Change Request

Number: 32
Date: 12/9/19
Job: 19050 Bonner Springs Govt Services
Phone:

Description: RFI 61 City Hall: Exterior Windows Detail Consideration

Subject: City Hall: Exterior Windows Detail Consideration

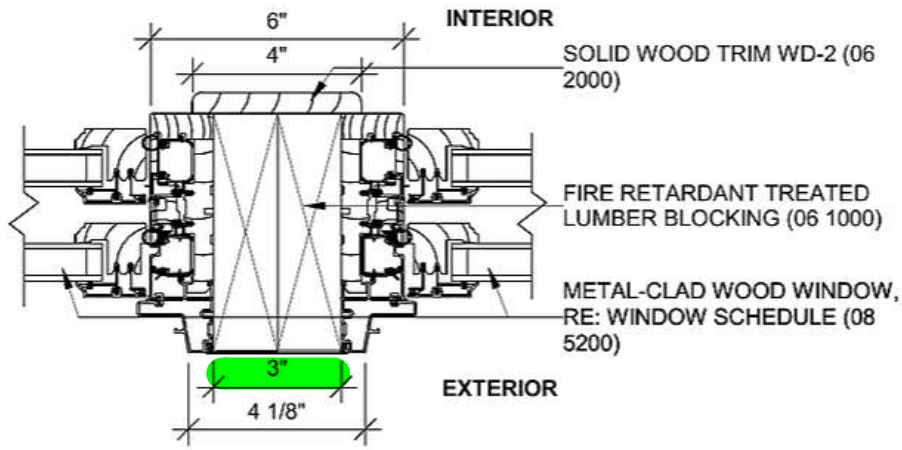
1. There is an existing unforeseen steel I beam supporting lintel at midspan of the large windows found on the East and West ends of the building (page 2). Detail C5/A611, shows the mullion between windows to be 3", however, the existing vertical I beam measures 3 1/8". During the initial visit by the window manufacturer, it was mentioned that a 4" mullion cover is also an option. Please advise.
2. There is an existing concrete sill at the windows projecting 1" +/- above the sill bricks at exterior and continued down through first course of brick, leaving 2 1/4" difference between remaining brick and brick sill (page 3). As our new window sill, detail B3/A611, shows a 3/4" piece of dimensional lumber sitting atop of the sill course, we assume the 2 1/4" +/- should be infilled with dimensional treated lumber. Please advise.

1. IT IS ACCEPTABLE TO USE A 4" MULLION COVER.
 2. INFILL OF 2-1/4" GAP WITH TREATED WOOD BLOCKING IS ACCEPTABLE.
- DIRK HENKE / SFS / 2019-10-10
